| LINE | QUANTITY | UOP | CAT NO. | ITEM NUMBER | UNIT PRICE | AMOUNT |
|------|----------|-----|---------|---|------------|--------|
| | | | | ADDENDUM NO. 2 | | |
| | | | | 3. TO PROVIDE REVISED DETAILED CROSS-SECTION DRAWINGS ATTACHED AS DRAWINGS 19A AND 19B. | | |

**Addendum #2 - Questions During Pre-Bid Conference
For DEP16103
Delta Mining / Pierce Coal & Const.
Permits U-2024-87 / 71-80**

| ALKALINITY CELL - SECTION | | |

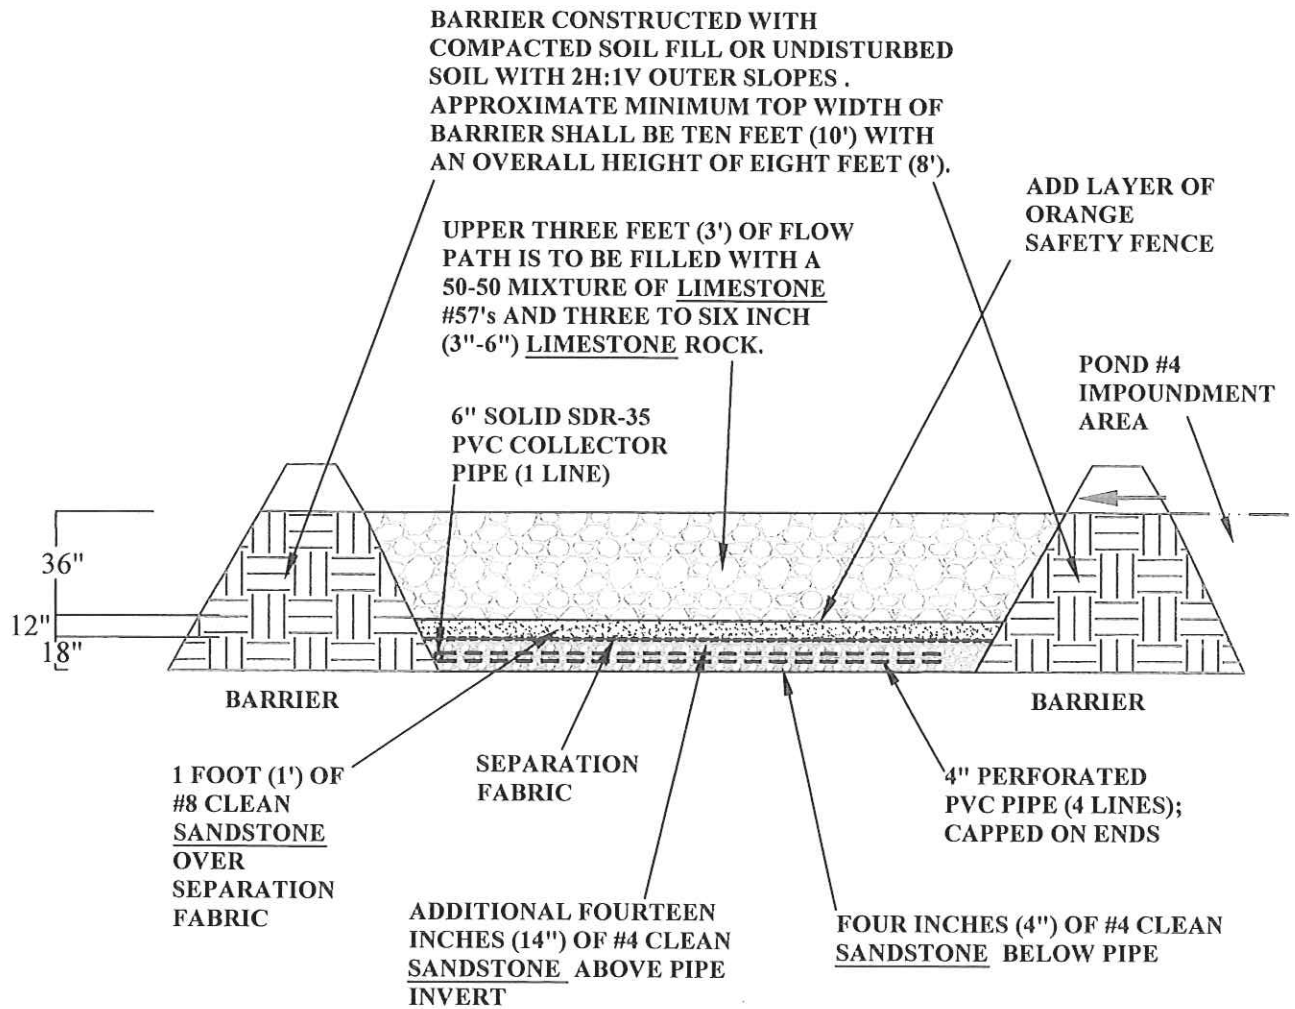
Bid Item #37.0 – As discussed on-site and in the attached specification and drawings #19A and #19B, the alkalinity cell will require the addition of a layer of orange plastic safety fencing between the #8 clean sandstone and the upper 3-foot layer of limestone.

The floor of the cell shall be filled with 4-inches (4") of #4 screened 'clean' **sandstone** aggregate. After installing the 4-inch underdrain lines, an additional 14-inches of screened 'clean' **sandstone** aggregate shall be filled above the pipe invert for a total of 18-inches of aggregate. Separation fabric shall then be laid on top of the crusher run then one-foot of 1/4" to 3/8" **limestone** pea gravel (#8 screened 'clean' stone) over the fabric. A layer of orange plastic safety fencing shall then be installed in the alkalinity cell on top of the #8 clean sandstone layer and prior to adding the upper 3-foot layer of limestone.

| ALKALINITY CELL - SECTION | | |

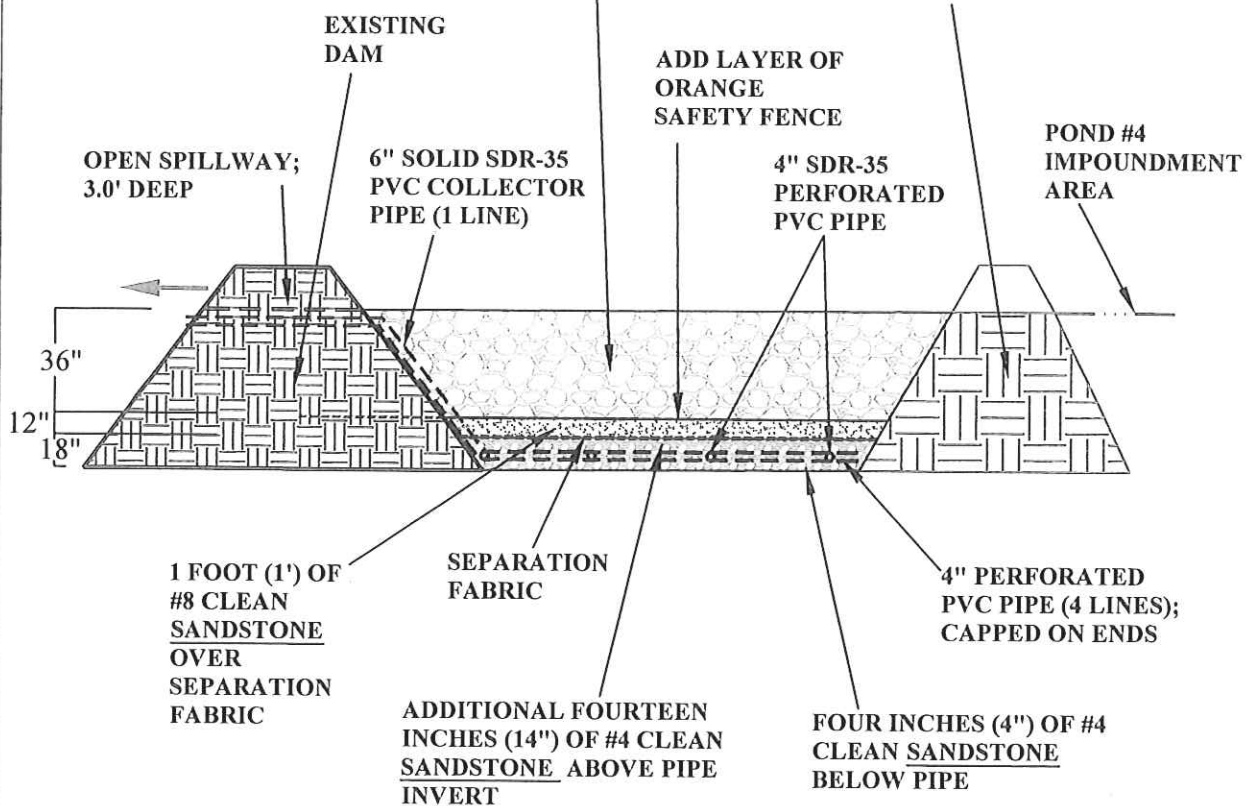
UPPER THREE FEET (3') OF FLOW PATH IS TO BE FILLED WITH A 50-50 MIXTURE OF LIMESTONE #57's AND THREE TO SIX INCH (3"-6") LIMESTONE ROCK.

BARRIER CONSTRUCTED WITH COMPACTED SOIL FILL OR UNDISTURBED SOIL WITH 2H:1V OUTER SLOPES. APPROXIMATE MINIMUM TOP WIDTH OF BARRIER SHALL BE TEN FEET (10') WITH AN OVERALL HEIGHT OF EIGHT FEET (8').
